USB Power Delivery ENGINEERING CHANGE NOTICE

Title: Generic Transition Diagram

Applied to: USB Power Delivery Specification Revision 3.2

Figure 7-23 “Generic Change for the Source to another (A)PDO”

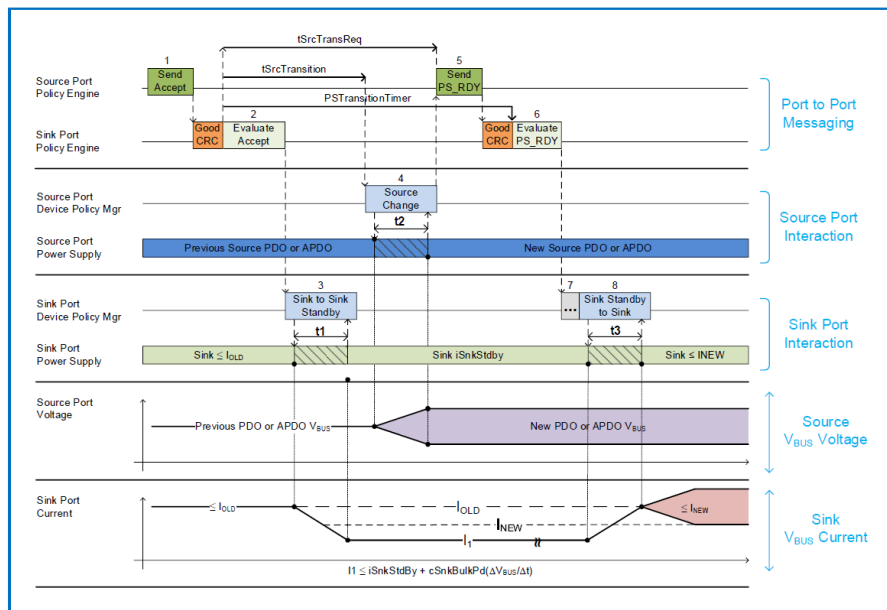
Brief description of the functional changes proposed:
Fig 7-23 'generic change for the source to another A/PDO' does not cover case when $I_{new} < I_{stdby}$. Fig 7-23 shows unwanted misalignment with fig 7-29 This ECN removes this figure and the associated table, as all situations are described in other figures.

The interaction of the Device Policy Manager, the port Policy Engine and the Power Supply that **shall** be followed when increasing the current is shown in [Figure 7-23 “Generic Change for the Source to another \(A\)PDO”](#).

The sequence that **shall** be followed is described in [Table 7.1 “Sequence Description for Changing the Source to another \(A\)PDO”](#). The timing parameters that **shall** be followed are listed in [Table 7.25 “Source Electrical Parameters”](#), [Table 7.26 “Sink Electrical Parameters”](#), and [Table 7.27 “Common Source/Sink Electrical Parameters”](#). Note in this figure, the Sink has previously sent a **Request** Message to the Source.

Remove full section 7.3.1.1.1

that **Shall** be followed when increasing the current is shown in *Figure 7-25 “Transition Diagram for Increasing the Voltage and Current”* and *7-27 “Transition Diagram for Decreasing the Voltage and Increasing the Current”*. The Source Voltage as the transition starts **Shall** be any Voltage within the **Valid** V_{BUS} range of the previous Source PDO or APDO. The Source Voltage after the transition is complete **Shall** be any Voltage within the **Valid** V_{BUS} range of the new Source PDO or APDO. The sequence that **Shall** be followed is described in *Table 7.3 “Sequence Diagram for Increasing the Voltage and Current”* and *Table 7.5 “Sequence Description for Decreasing the Voltage and Increasing the*
